SURRY POWER STATION, UNIT NO. 1

Amendment No. 45
License No. DPR-32

Amendment No. 45
License No. DPR-37

4.13 NONRADIOLOGICAL ENVIRONMENTAL MONITORING PROGRAM

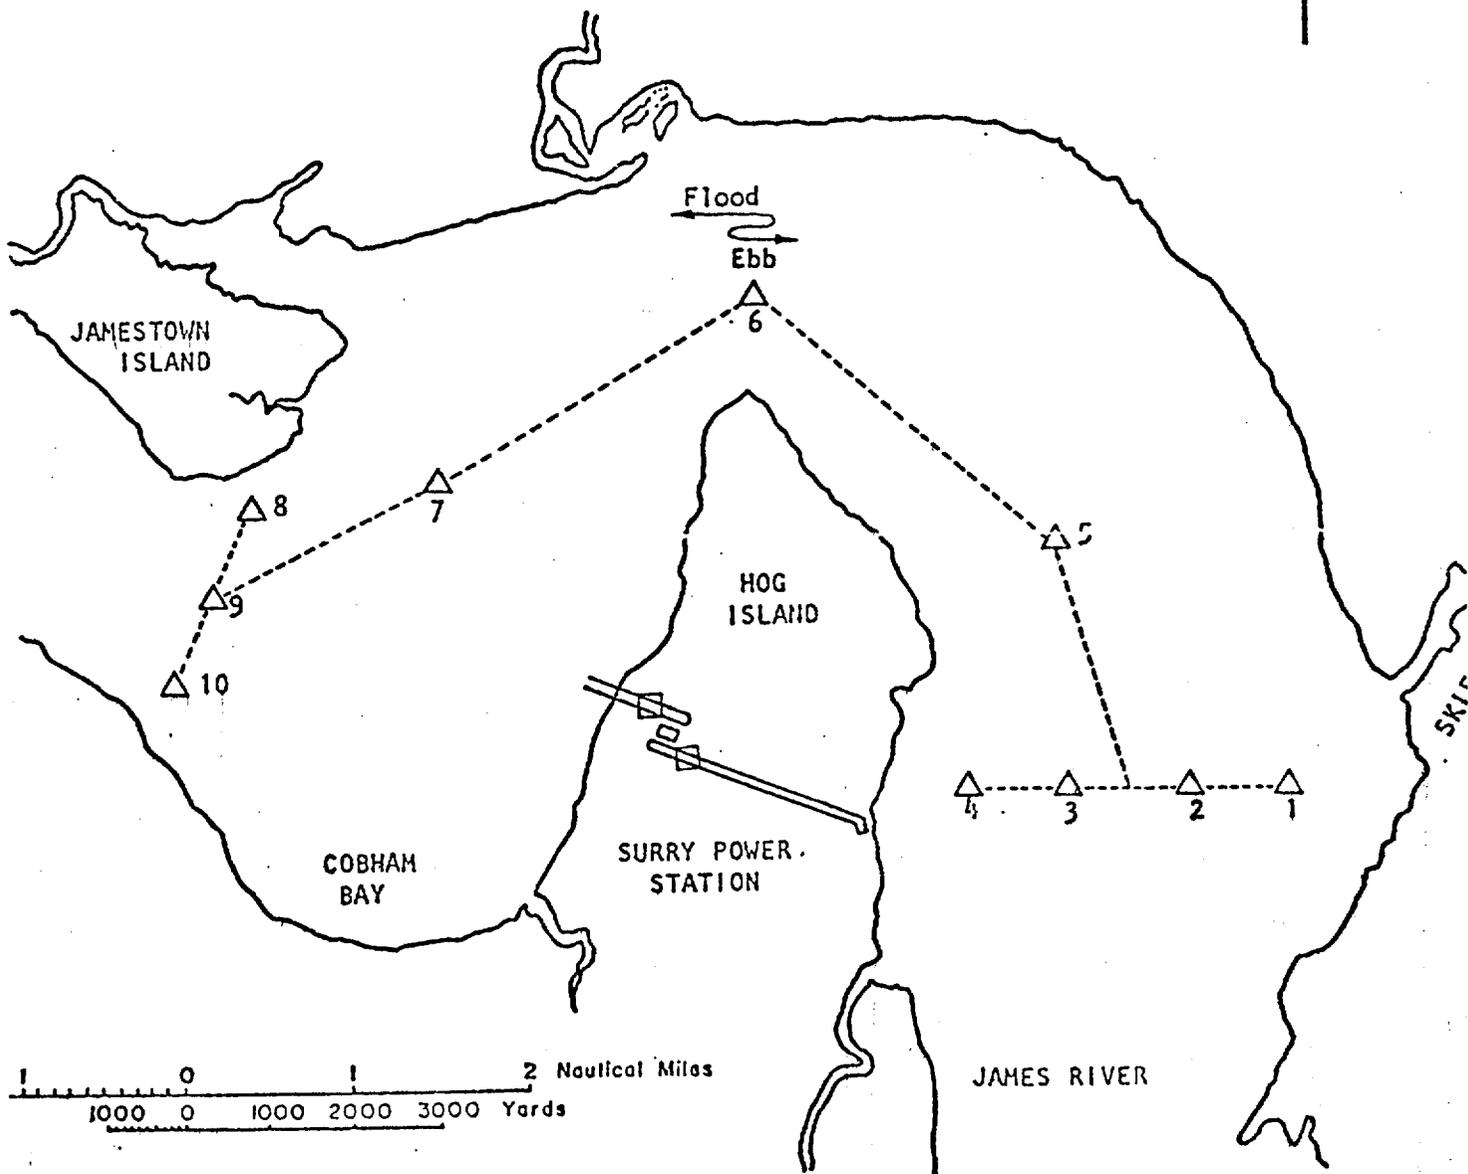
- A. A monitoring program shall be conducted to determine the relationship between the thermal discharge and the physical-chemical characteristics of the water mass within the 10-mile tidal segment centered at Hog Island.
1. The monitoring program shall encompass the segment of the James River Estuary which extends from below the intake of the Surry Power Station upstream to the southern shore of Jamestown Island as shown on TS Figure 4.13-1.

2. The horizontal and vertical temperature-salinity structure of the tidal segment shall be determined at monthly intervals as follows: Cruises shall be conducted at slack before flood tide. A four (4) station transect shall be established between the intake structure and Skiffes Creek just before low slack water. Temperature and salinity data shall be collected at two (2) meter intervals from surface to bottom. The cruise shall continue up the channel with same slack stations established at approximately two (2) mile intervals in the middle of the river. The final transect shall be made between Jamestown Island and Crouches Creek.

SURRY
POWER STATION

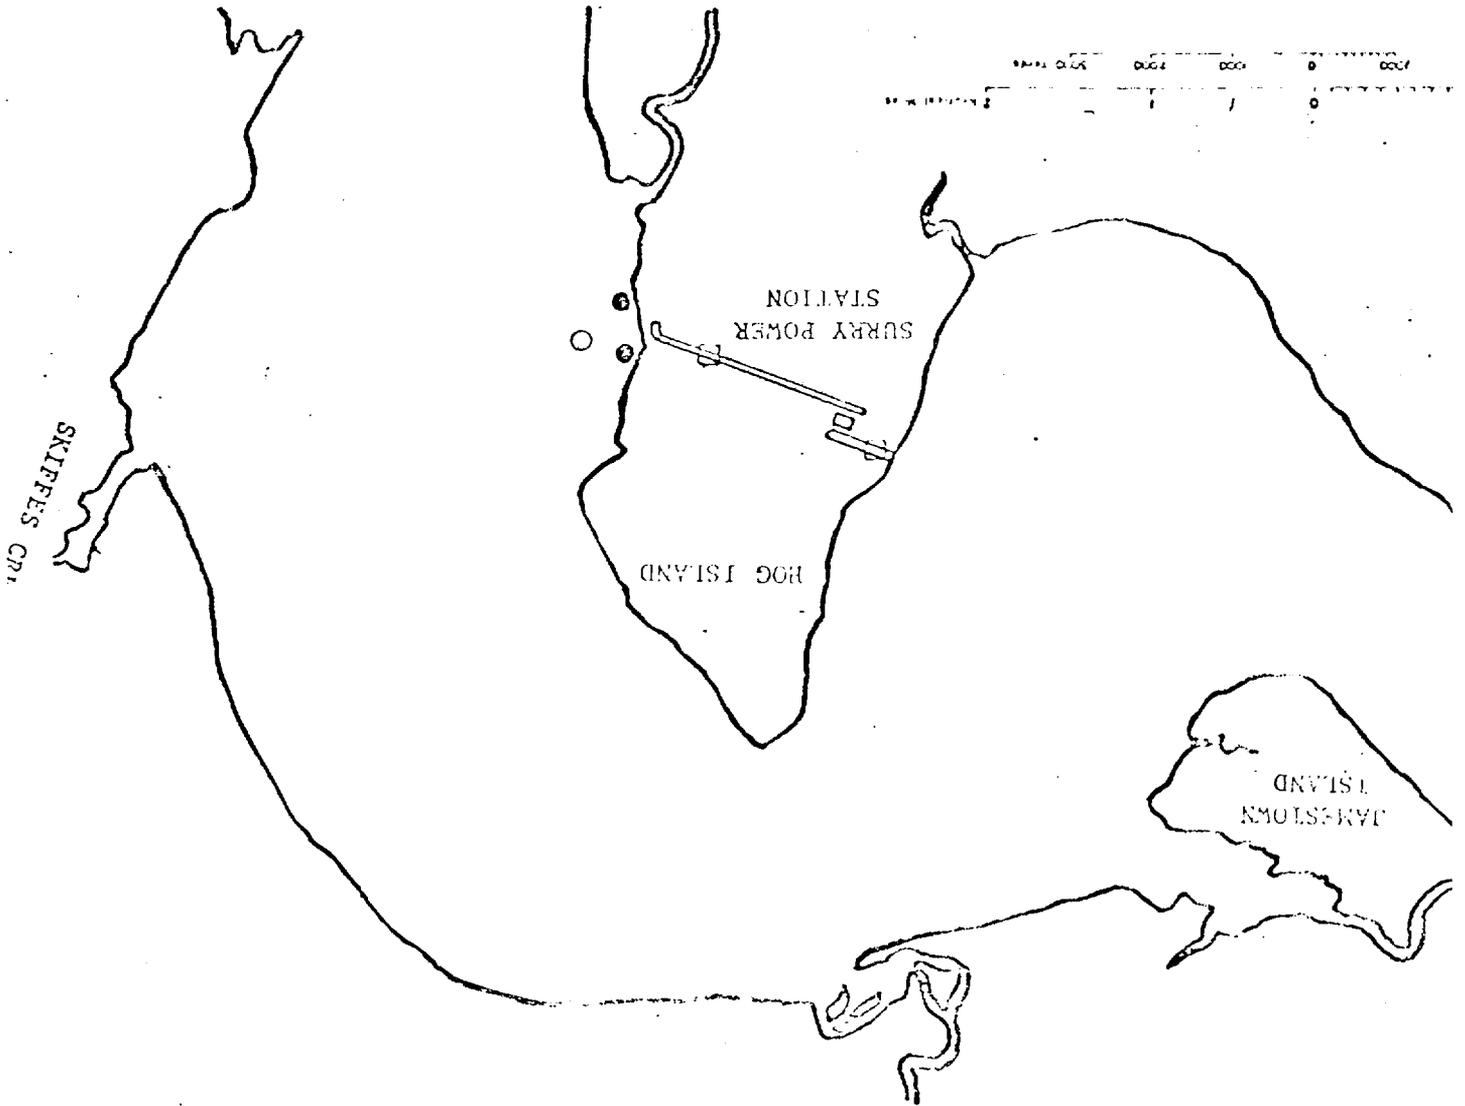
B. A fish sampling program in the vicinity of the intake structure shall be conducted. Monthly trawls and seine hauls will be taken at stations identified in TS Figure 4.13-2. Concurrent temperature and salinity measurements shall be made with the trawls and seine hauls.
